DEVELOPMENT REVIEW BOARD REPORT

Meeting Date: October 20, 2016 Item No. 4
General Plan Element: *Character and Design*
General Plan Goal: *Foster quality design that enhances Scottsdale as a unique southwestern desert community.*

14950 N. 83rd Place
27-DR-2016

Request: Request approval of the site plan, landscape plan, and building elevations to renovate the exterior of an existing two-story commercial building with approximately 20,000 square feet of building area on an approximately 1.20-acre site.

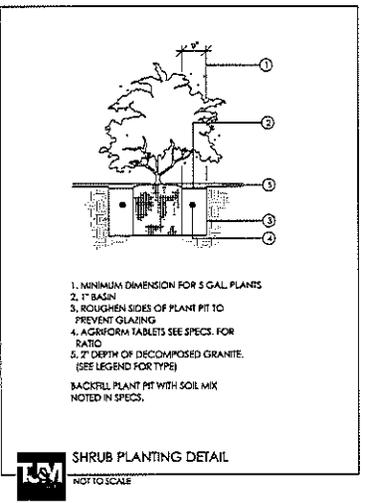
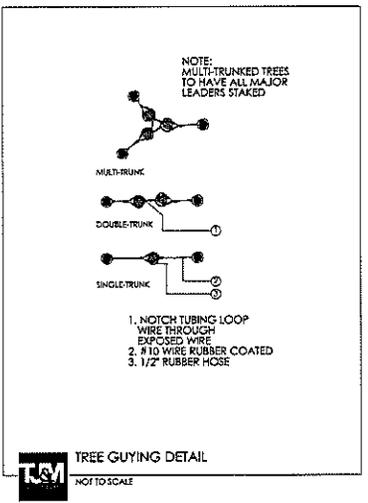
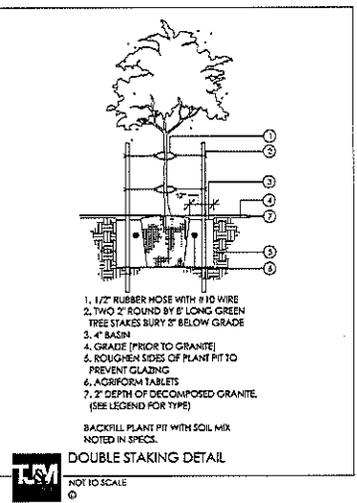
6. Based on the mature size of the proposed plants, at final plans submittal, please modify the Landscape Plan so that the planting density and layout is representative of the mature size of the proposed species, relative to the planting area. In general, a twenty to thirty percent (20% - 30%) reduction of planting intensity should be implemented in order to avoid overcrowding of plants, and so that there will be no need to trim excessively or shear the plants, resulting in sustainable landscape improvements.

7. At final plans submittal, please coordinate the Landscape Plan with the Lighting Plan in order to avoid conflicts between the size of mature trees and light fixtures. Please shift either the location of any proposed or existing trees or any location of proposed light fixtures so that there is at least twenty (20) feet between tree trunks and light fixtures.

8. At final plans submittal, the owner shall submit landscape improvement plans that demonstrate how any salvaged vegetation from the site will be incorporated into the design of the landscape improvements.

9. At final plans submittal, please indicate on the landscape improvement all existing plants that will be removed. Any protected native plant proposed to be salvaged or removed shall require a native plant permit (refer to Stipulation A).
